REMARKS

Docket No.: FUSA 17.792 (100807-16878)

FIG. 40 PRIOR ART

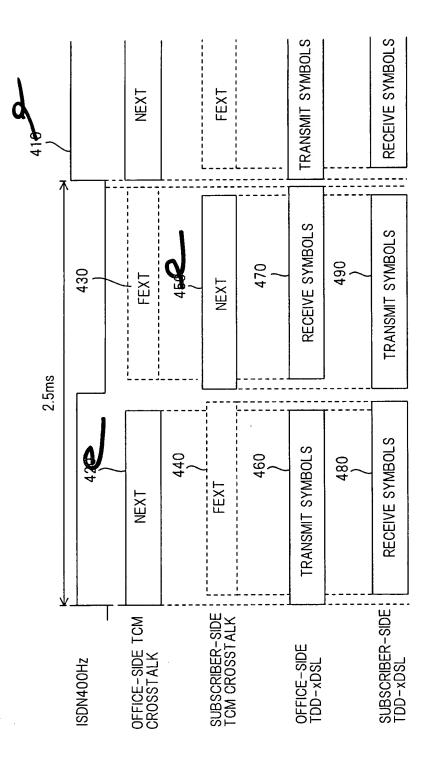
The originally filed drawings have been objected to by the Examiner because they include reference signs 410, 420 and 450 (Fig.40) not mentioned in the specification. Applicants submit replacement pages, including both clean and marked-up versions, that eliminate reference signs 410, 420 and 450. Applicants respectfully request that the replacement pages be accepted, and that the objection be withdrawn.
